TO: Mayor Mario Avery, City of Fairburn
ATTN TO: Denise Brookins, Planning and Zoning Director, City of Fairburn
FROM: Mike Alexander, COO, Atlanta Regional Commission
RE: Development of Regional Impact (DRI) Review

Name of Proposal: Fairburn Technology

Description: A DRI review of a proposal to construct a data center project with 1,190,000 million Sf of space in three two-story buildings and supporting facilities on a 60-acre site on Bohannon Road in the City of Fairburn in Fulton County.

DRI #4213

SHEET CP-13A

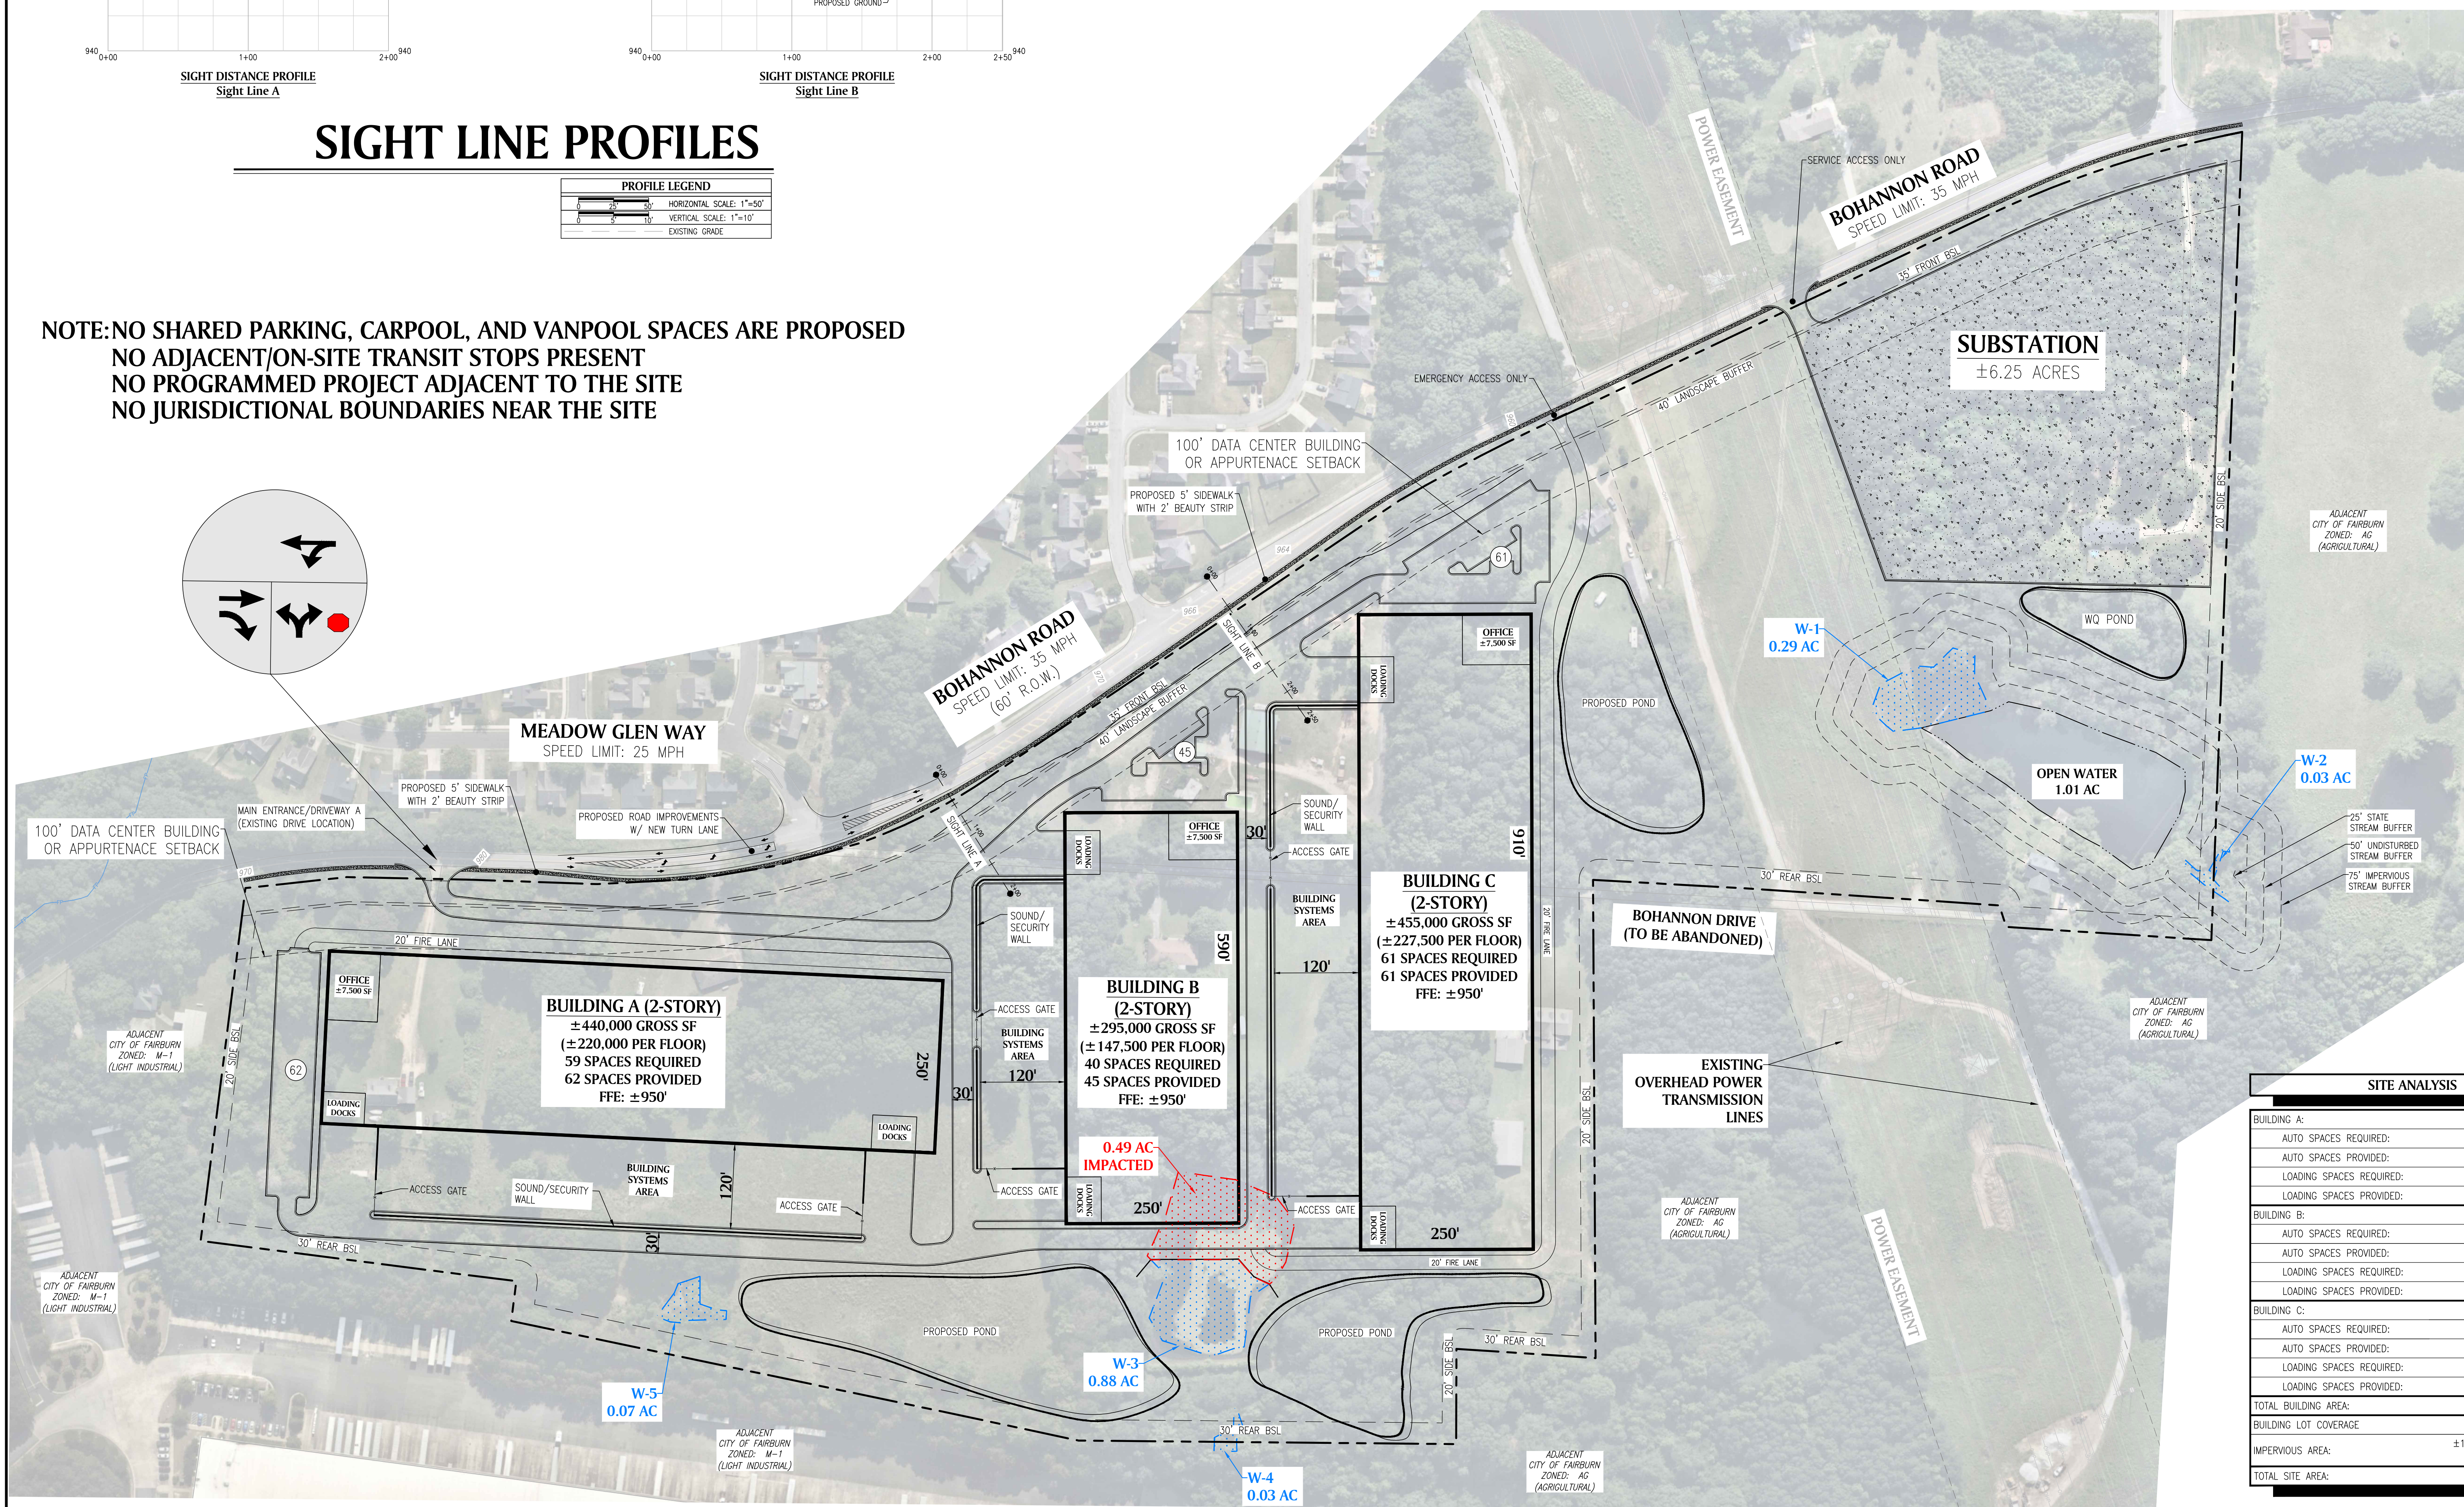
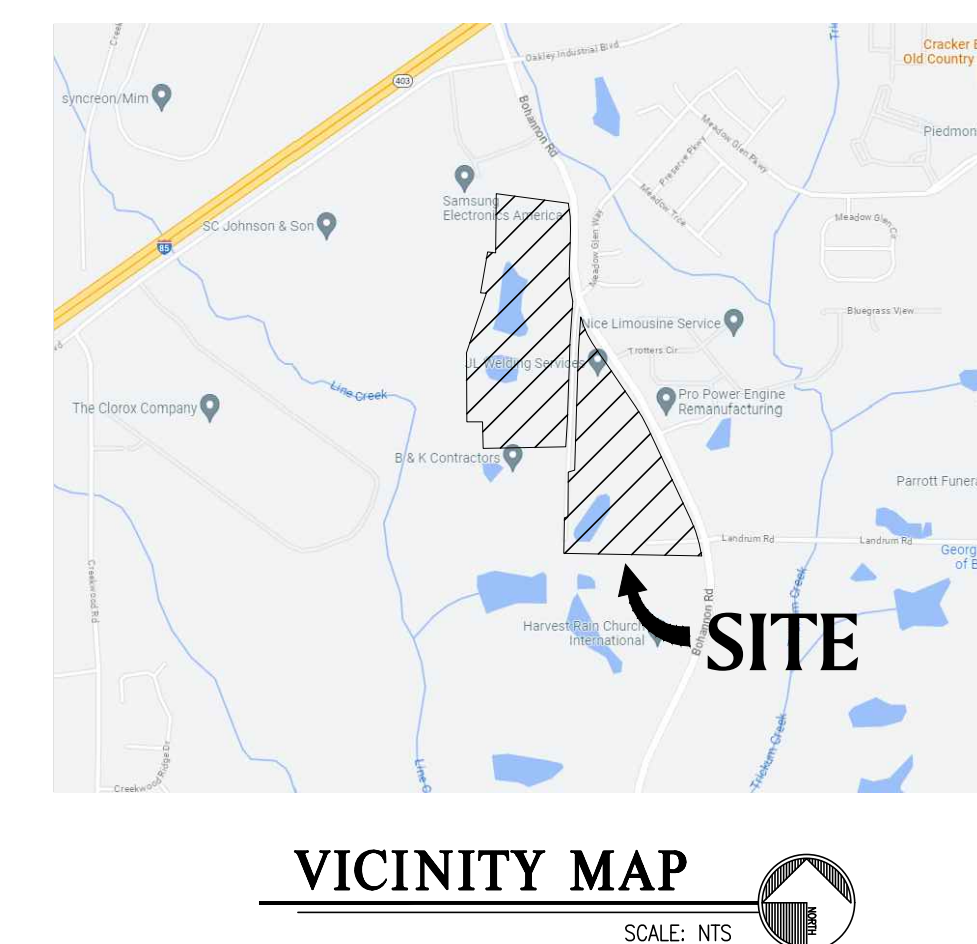
Multiple stormwater retention ponds are proposed which will require removal of large numbers of trees. An effort should be made to reduce the footprint of these ponds through deepening or consolidation. It is strongly recommended that some of the large amount of revenue generated by the project be earmarked for the acquisition and preservation of natural areas elsewhere in the City.

Neither the USGS coverage for the project area nor the proposed project site plan show any streams on the project property. The submitted site plan shows an existing pond and adjacent wetlands surrounded by the State 25-foot Sediment and Erosion Control buffer as well as a 50-foot undisturbed buffer and a 75-foot impervious surface setback. Buffers beyond the State Sediment and Erosion Control buffer are not specifically required on non-water supply ponds under either the Part 5 Criteria or the Fairburn Stream Buffer Ordinance.
